Re: Zoning Board application resubmittal
Addition and alteration to
Existing 1 family dwelling
6 Fulton Street
Hastings on Hudson, New York
DAB Job # 160901

Attached please find 8 copies of revised drawings addressing comments of the last Zoning Board meeting. The attached package contains the original application package and revised drawing indicating the two (2) major concerns the Board, and adjacent neighbors voiced.

Proposed addition and alteration to
existing 1 family dwelling
6 Fulton Street
Hastings-on-Hudson, New York
66H-2-30

SITE GRADING PLAN

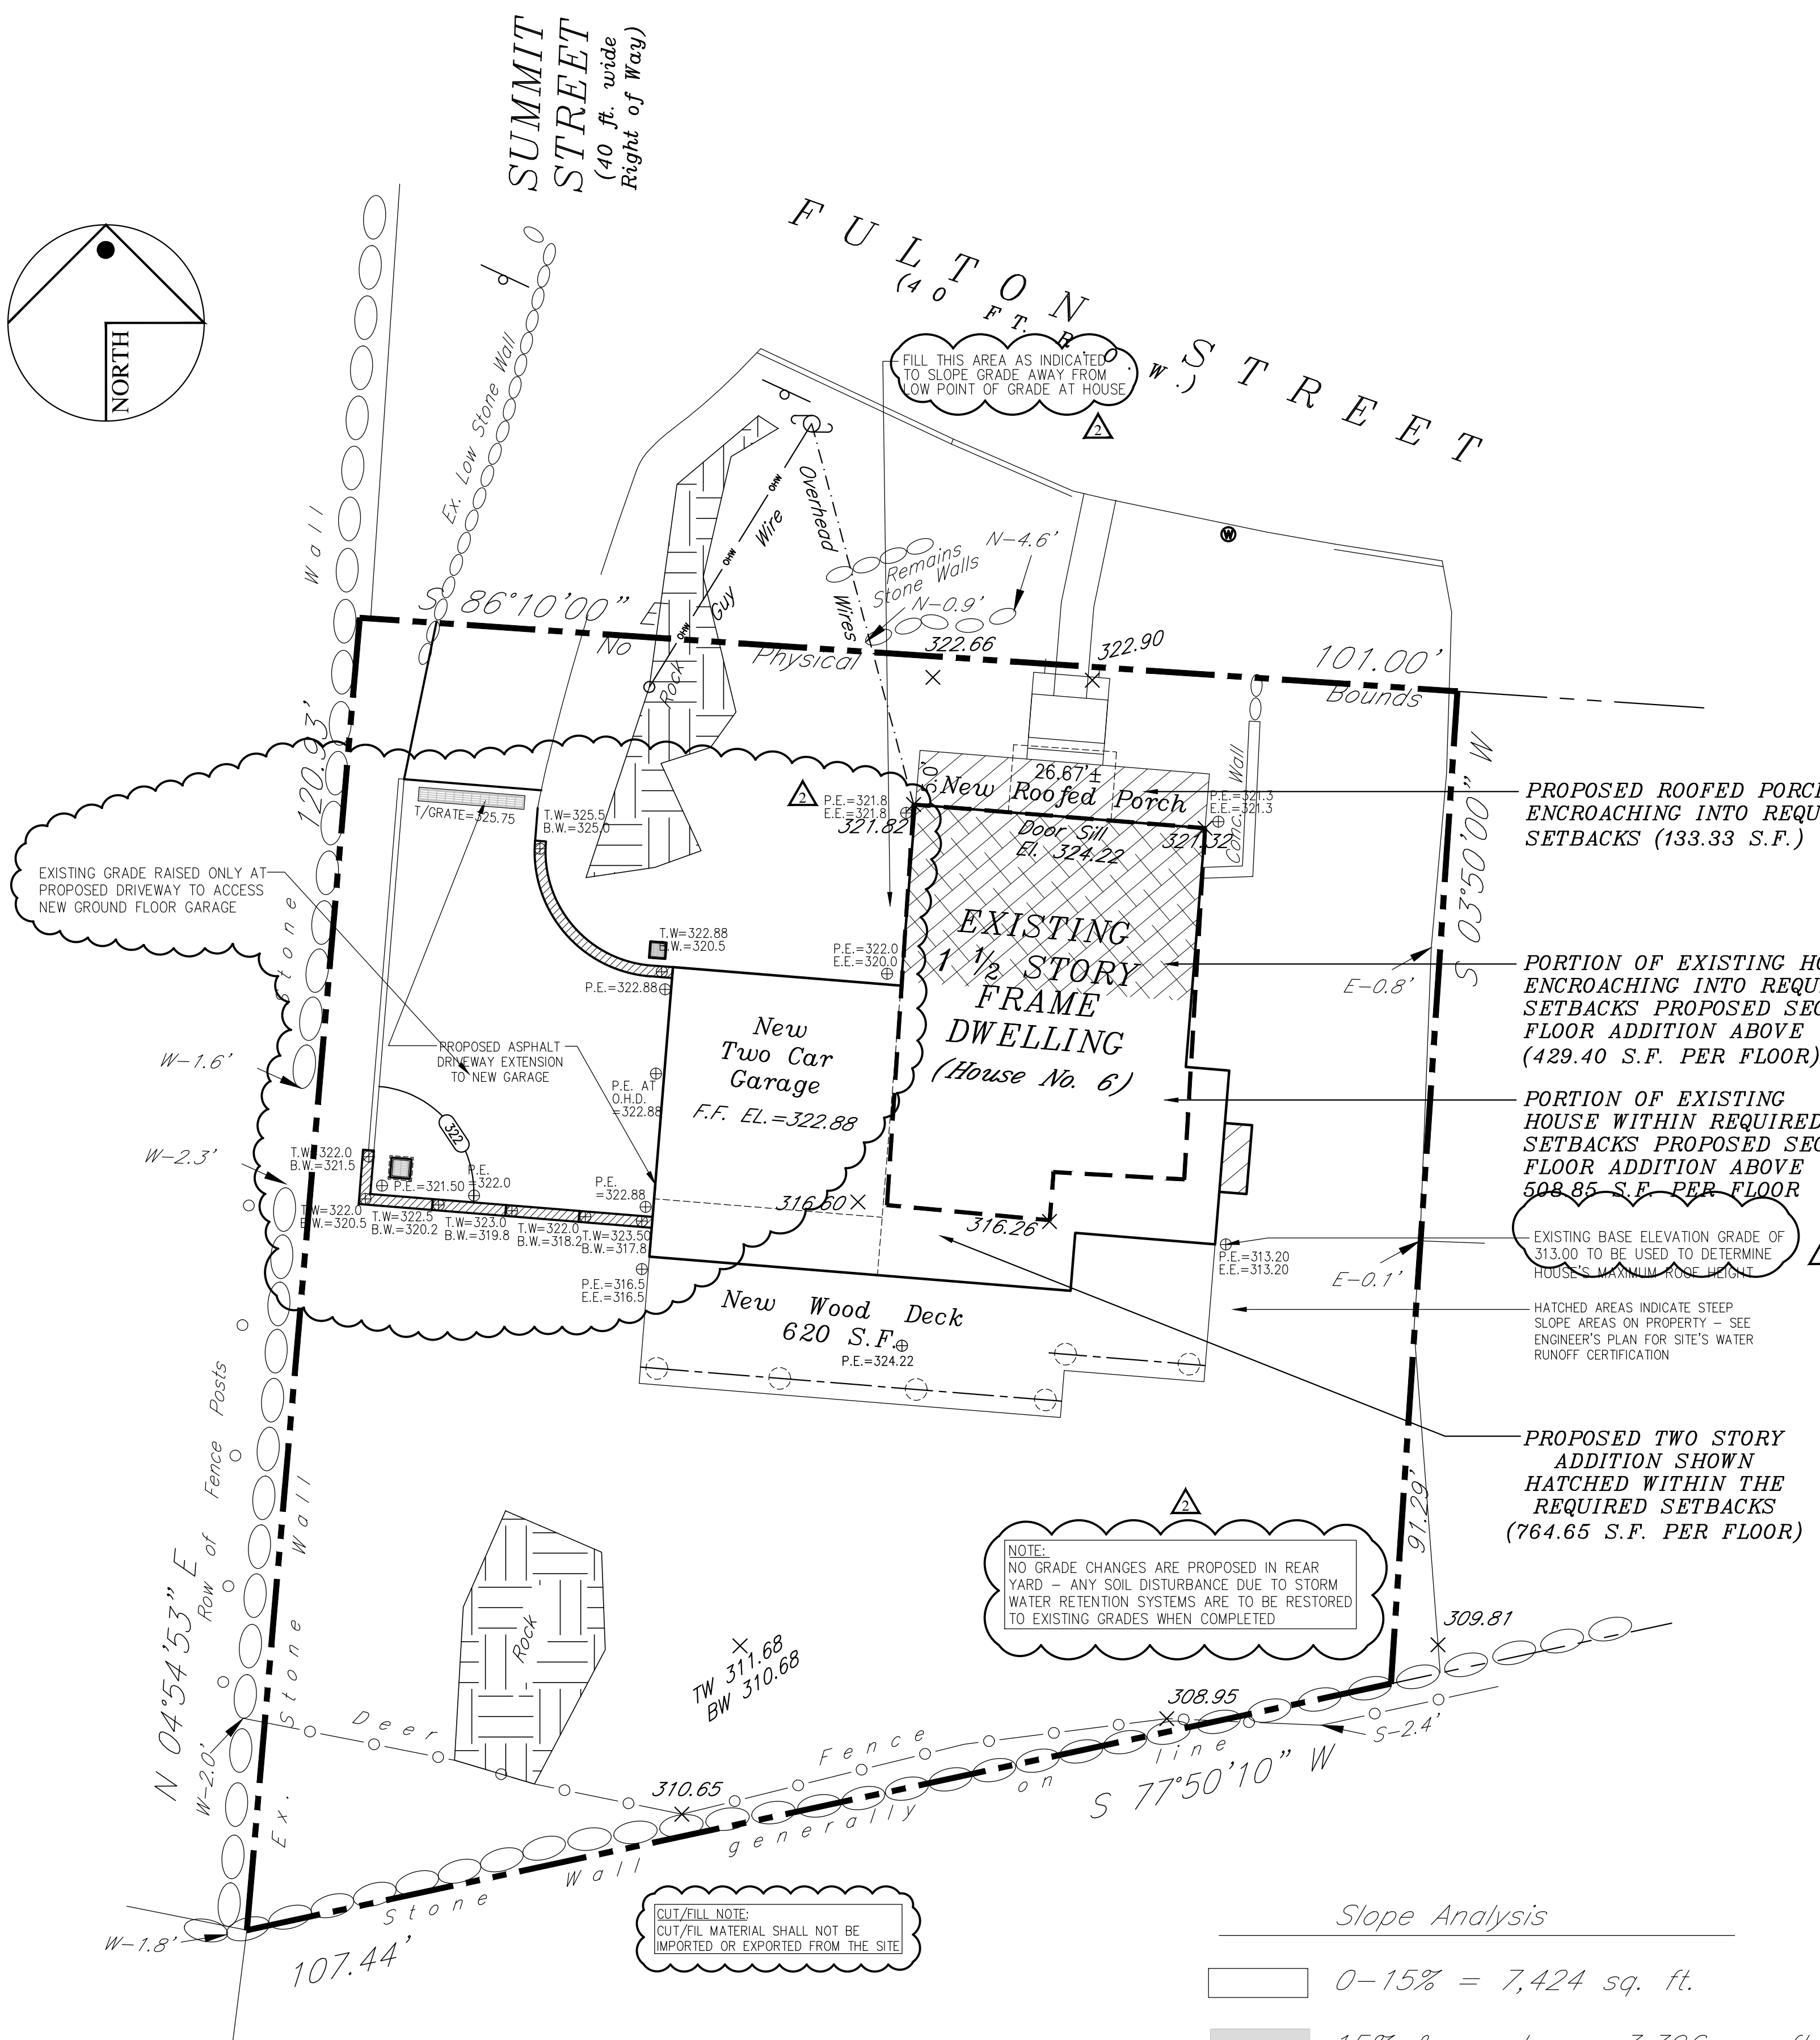
REV	BY	DATE	DESCRIPTION
1	C.P.	12-20-16	REVISED STORM WATER PLAN AND DETAILS PER COMMENTS FROM TOWN ENGINEER, PC DATED 12-15-16
2	C.P.	12-14-16	REVISED HOUSE TO MOVE PROPOSED GARAGE WINGS TO BEHIND THE FRONT YARD SETBACK. WALL HEIGHT TO SIDE NEIGHBOR
3	C.P.	12-1-16	REVISED STORM WATER DRAINAGE SYSTEM AND COMMENTS
4	C.P.	11-21-16	REVISED STORM WATER DRAINAGE SYSTEM AND COMMENTS
